**Planning &
Environment**

**MODIFICATION REQUEST TO CONCEPT
APPROVAL AND STATE SIGNIFICANT
DEVELOPMENT ASSESSMENT REPORT:**

**Concept Approval MOD 9
SSD Application for Block 8**

MP 06_0171 MOD 9 and SSD 6092

Figure 4: Comparison between Concept Approval and proposed envelope of Block 8 (Source: Applicant's RtS)

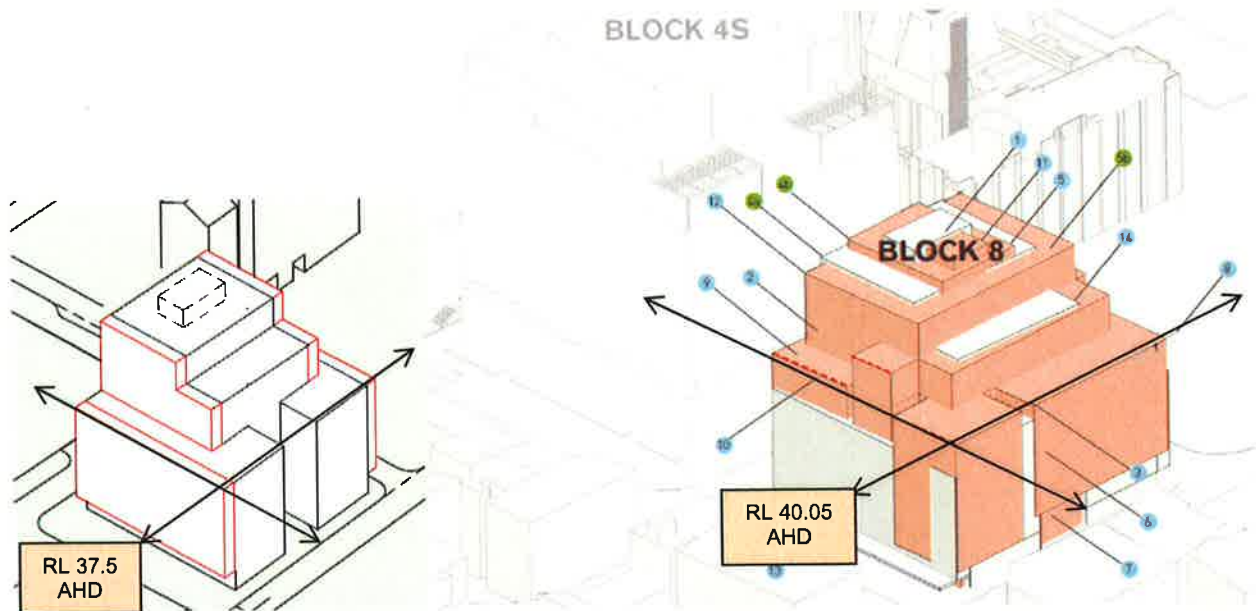
A key concern raised by the Department (and within public submissions) was the additional height and bulk and associated amenity impacts to nearby properties resulting from the modified building envelope when viewed from Abercrombie Street (west) and O'Connor Street (south).

The proposal seeks to both increase the height of the Abercrombie Street and O'Connor Street facade by 2.55 metres and delete the large slot in the façade (a reduced slot is provided to the west), as shown in **Figure 4**.

The Department considers that the scale of the building maintains the transition from Block 4S immediately to the north, by stepping down in height towards O'Connor Street (immediately adjoining to the south is a four storey approved development and other two to three storey buildings) and the varied heights on the Abercrombie Street frontage add visual interest to the roofline. The increase in height of the street edge to Abercrombie and O'Connor Street (notwithstanding the project above the streetwall) provides a consistent reference height to the heritage brewery building and achieves the transition envisaged in the Concept Approval.

Figure 6: Comparison between approved and proposed overshadowing at 9.30am on June 21 as a result of revised Block 8 envelope (Source: Proponent's RtS)

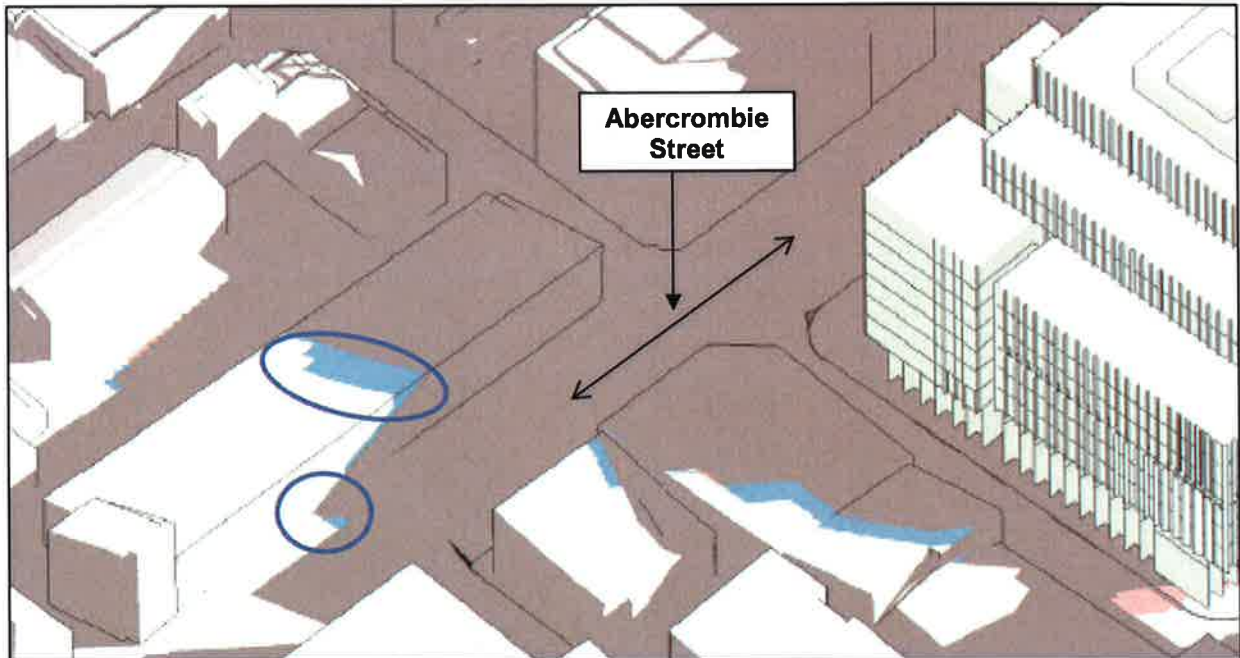
The proposal results in an increase in shadows to neighbouring properties to the west, particularly the eight terraces between 41-57 Abercrombie Street up to 10.30am during midwinter (June 21).

The proponent's shadow analysis indicates that impacts primarily occur on rooftops (**Figure 6**), and that all properties with frontage to Abercrombie Street will retain their existing solar access from 11:00am (**Figure 7**).

The Department accepts that the additional overshadowing primarily occurs over rooftops or along the eastern elevation of Abercrombie Street residences.

Figure 8: Comparison between approved and proposed overshadowing at 1.30pm on June 21 as a result of revised Block 8 envelope (Source: Proponent's RtS)

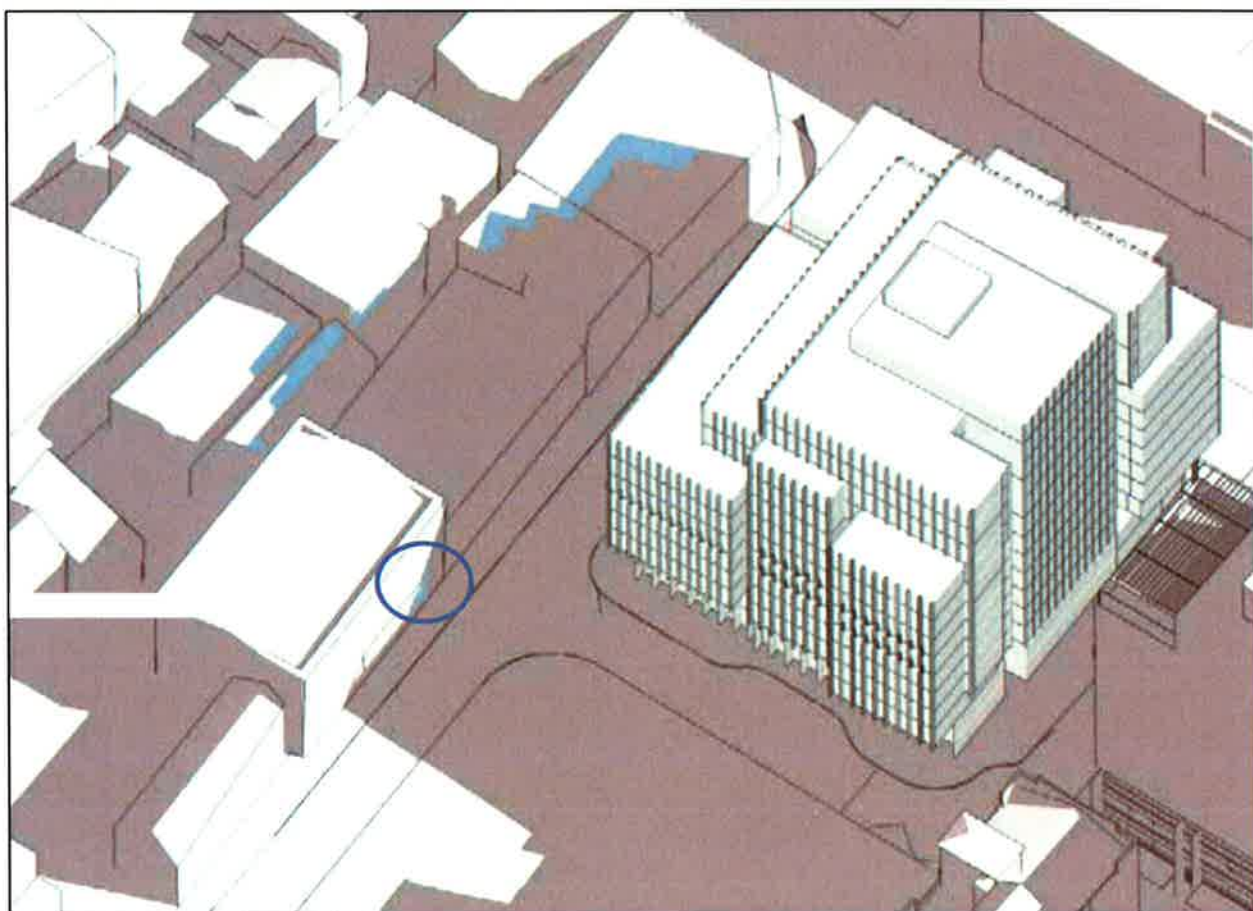
The proposal causes minor additional overshadowing to O'Connor Street properties during mid-winter, between 1.00pm and 2.30pm. The extent of additional overshadowing at 1.30pm is shown in **Figure 8**. The rooftops of buildings also receive additional overshadowing, however this does not impact upon the amenity of these properties.

On this basis, the Department concludes that the overshadowing impact on O'Connor Street properties is acceptable in the context of the site's dense city edge urban location.

Figure 9: Comparison between approved (grey shadow) and proposed overshadowing (light blue shading) at 12.30pm on June 21 on residential area of Dick Street (Source: Proponent's RtS)

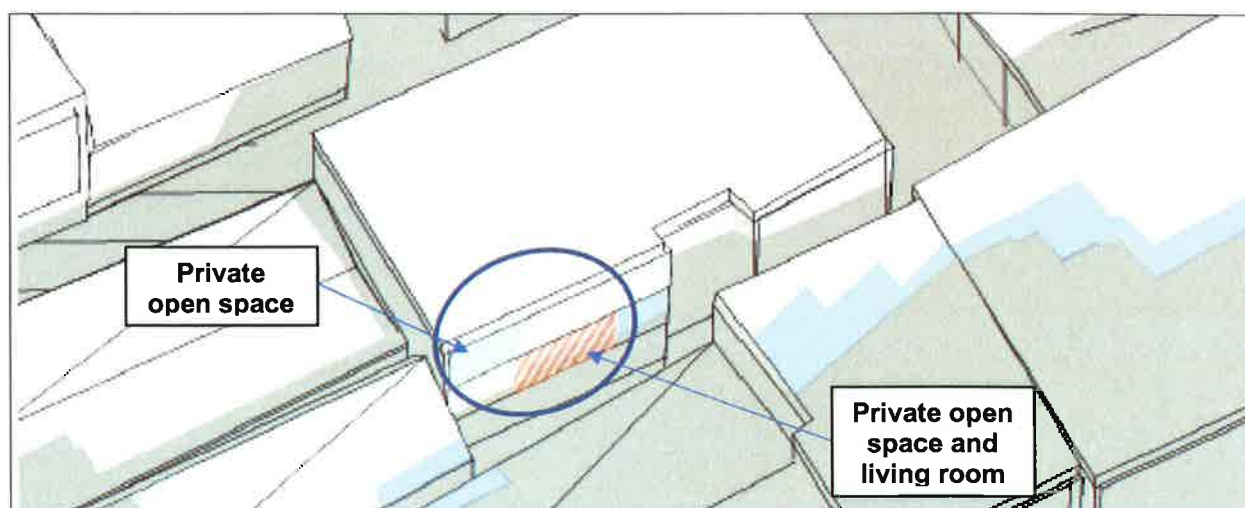
The proposal will also result in minor increases in shadowing to properties in Dick Street, which is located to the south of O'Connor Street and includes a mix of warehouse / residential uses. A public submission was received from a property on Dick Street that contains residential uses above ground level with views towards Block 8 (**Figure 9**).

The residential component of the property at Dick Street maintains 3 hours of solar access between the hours of 9.30am and after 12.30pm, mid-winter, which is acceptable noting that this exceeds the City of Sydney Development Control Plan 2012 requirement to achieve a minimum of 2 hours direct sunlight between 9am and 3pm on 21 June.

Figure 10: Building separation between Block 4S (top) and Block 8 (bottom) envelope (Source: Proponent's RtS)

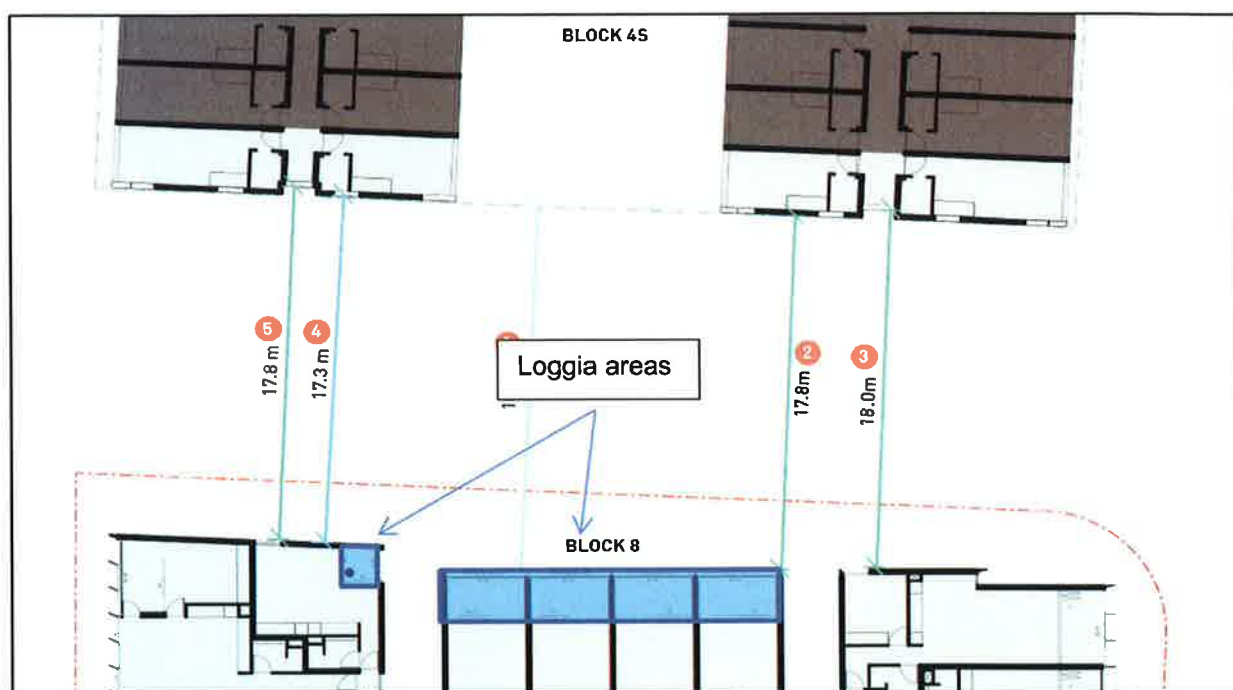
The proposal seeks to reduce the minimum building separation between Block 4S and Block 8 from 18 metres to a minimum of 17.3 metres (**Figure 10**) at Level 1 to 7, which does not meet the Residential Flat Design Code (RFDC) recommended separation distance of 18 metres.

Although the building separation does not strictly meet the RFDC recommendation, the variation of 0.7 metres is minor and the northern façade of Block 8 is opposed by either small windows on Block 4S or are offset to the windows in Block 8 (i.e. windows and open space areas are not directly opposite each other), which will provide adequate privacy between units.

The Department concludes that the proposed 0.7 metre reduction in separation distance is therefore acceptable.

Figure 13: Public domain treatments surrounding Block 8 (Source: Proponent's RtS)

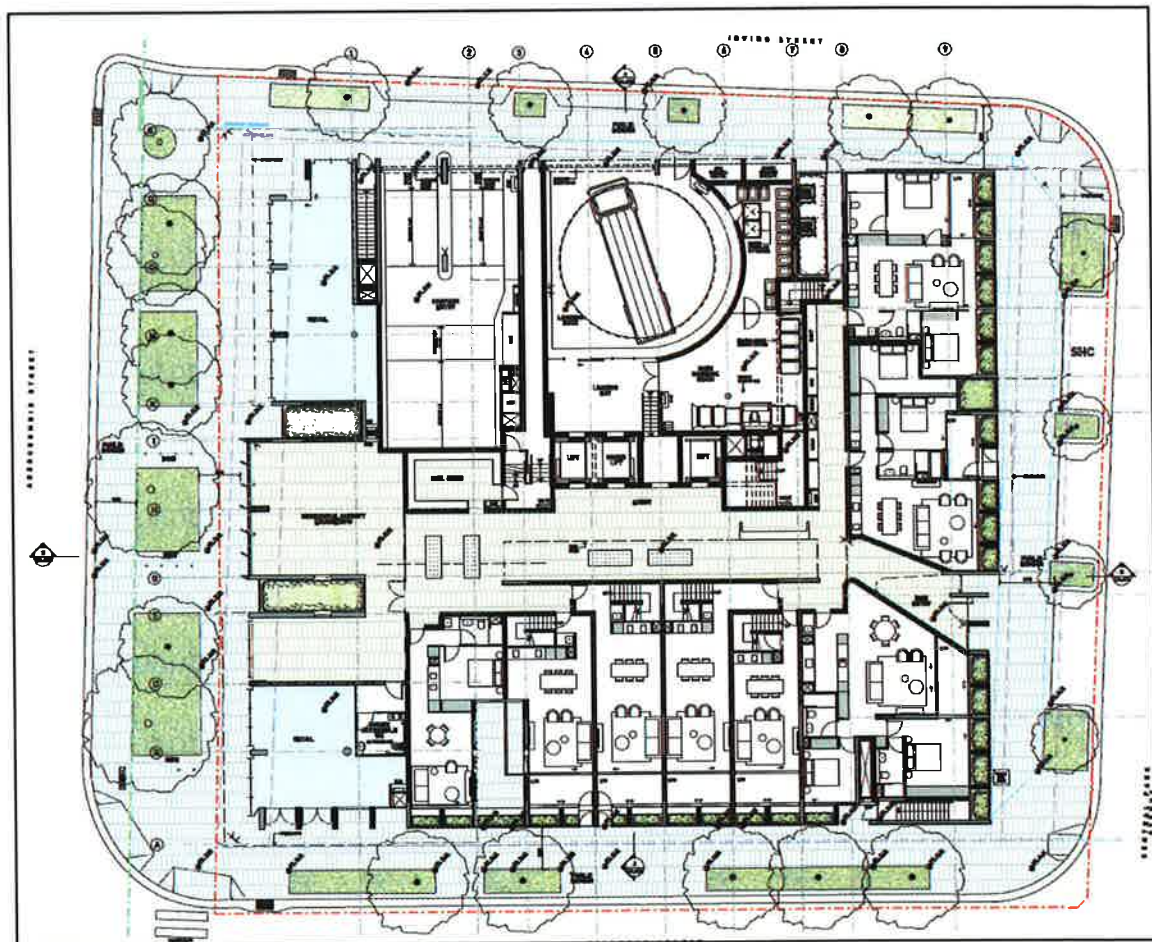
Council raised concerns that the overhang of the building from Level 1 and above would impact on proposed street trees provided within the public domain, particularly those on the corner of Central Park Avenue and Irving Street. Council recommended the deletion of a street tree at this location. The Department recommends Condition B6 to require Council's endorsement of the public domain / landscape plans prior to the relevant Construction Certificate for above ground works. This will enable further consideration of street tree placement in the detailed design.

The Department is of the view that the public domain provides a quality interface for pedestrians, retail visitors and occupiers of the building, is consistent with adjoining areas, and provides through site access without any impediments.

The Department concludes that the public domain treatments are suitable and will complement the existing public domain areas within the Central Park and also provide a transition to areas to the south.

Figure 16 Level 10 plan illustrating proposed measures to improve amenity between apartments (Source: Applicant's Additional Information to Council comments)

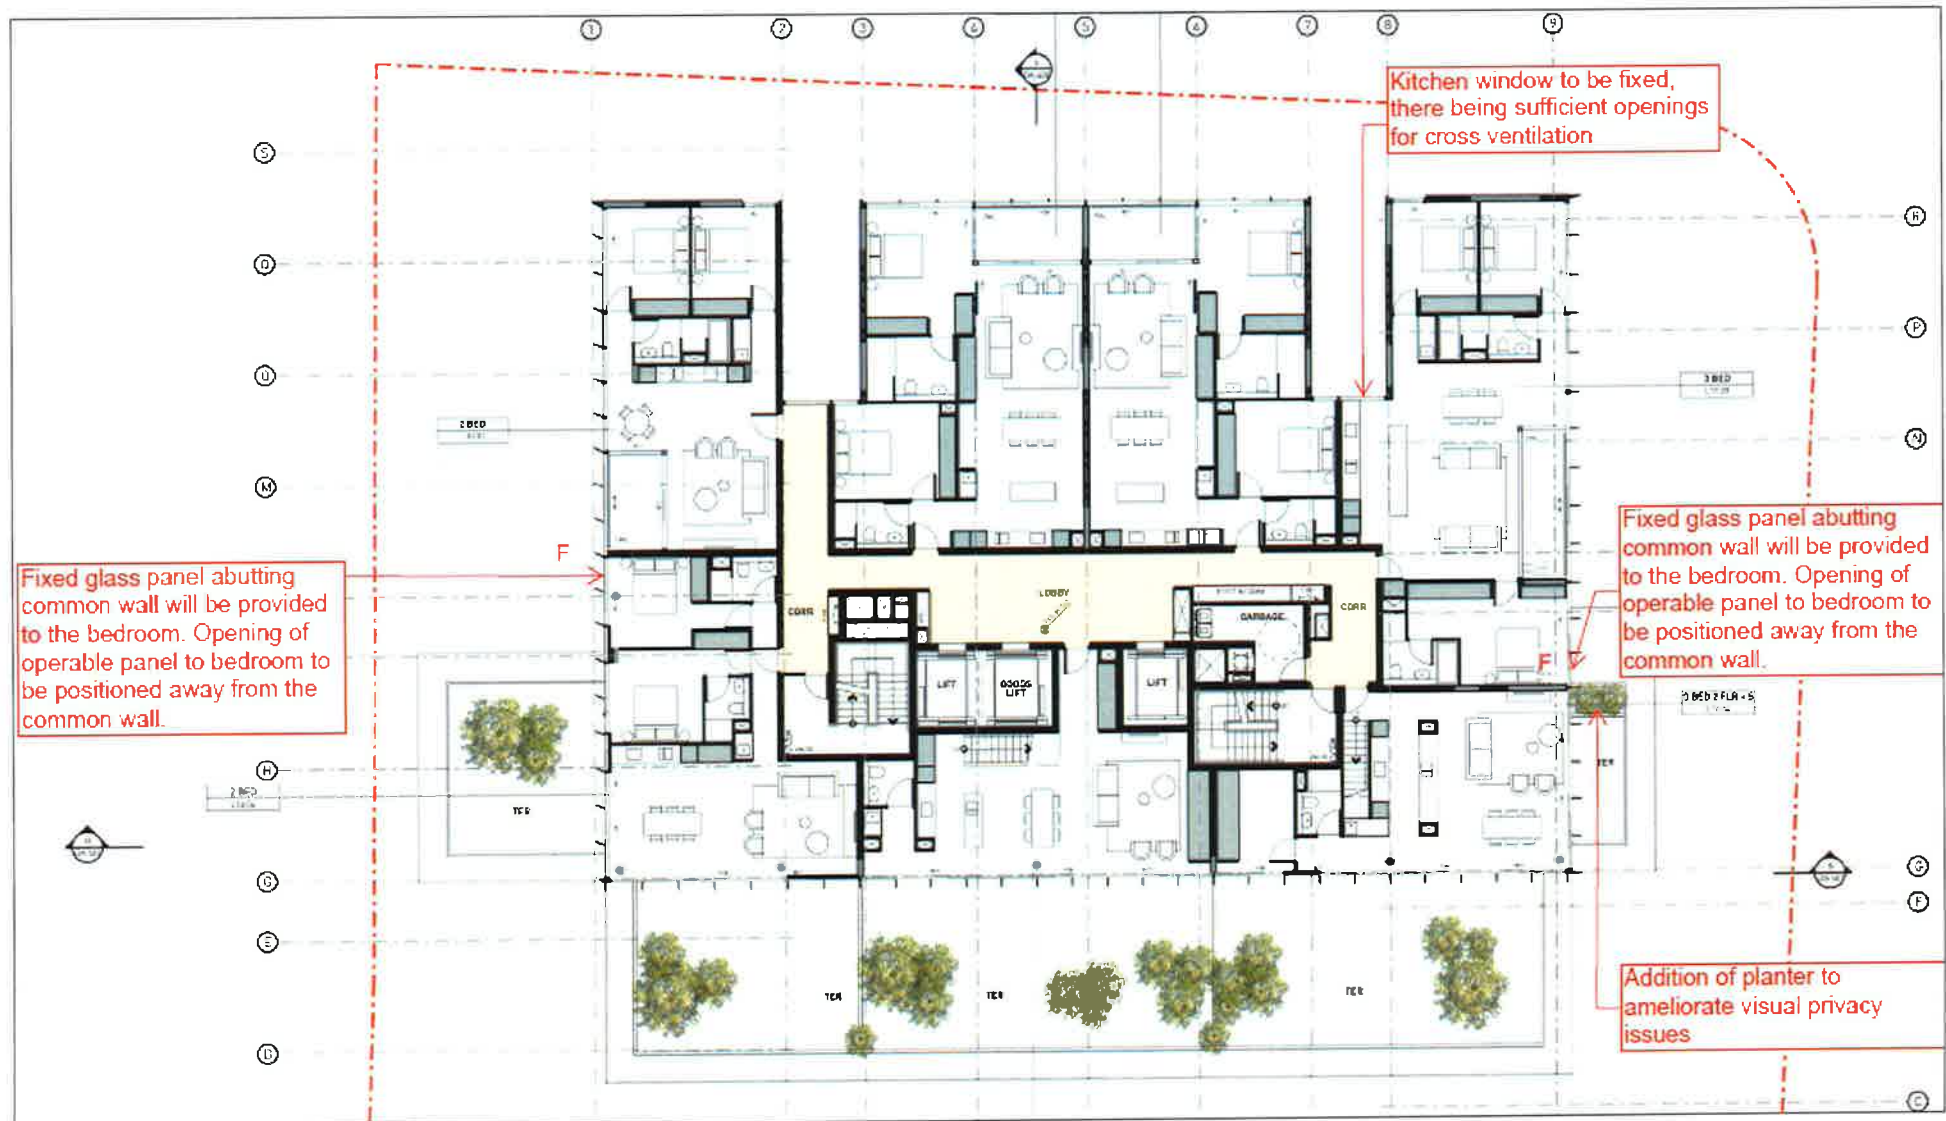
The applicant maintains that in most instances, Block 8 is designed where bedrooms of one apartment are not located adjacent to living areas of another. However, additional measures are proposed to address Council's concerns (**Figure 16**), including:

- kitchen windows being fixed closed (where apartments are already provided with cross ventilation) to prevent transfer of noise to bedrooms in adjoining apartments;
- planter boxes being installed to address potential visual and acoustic privacy concerns; and
- relocating the operable panels to bedrooms away from common walls and balconies.

The Department acknowledges that with the inclusion of the above measures, potential noise transfers between apartments are minimised and residential amenity of apartments are maximised. The measures proposed by the applicant are supported. Condition B3(d) is therefore recommended for amendments to apartments to address privacy concerns.
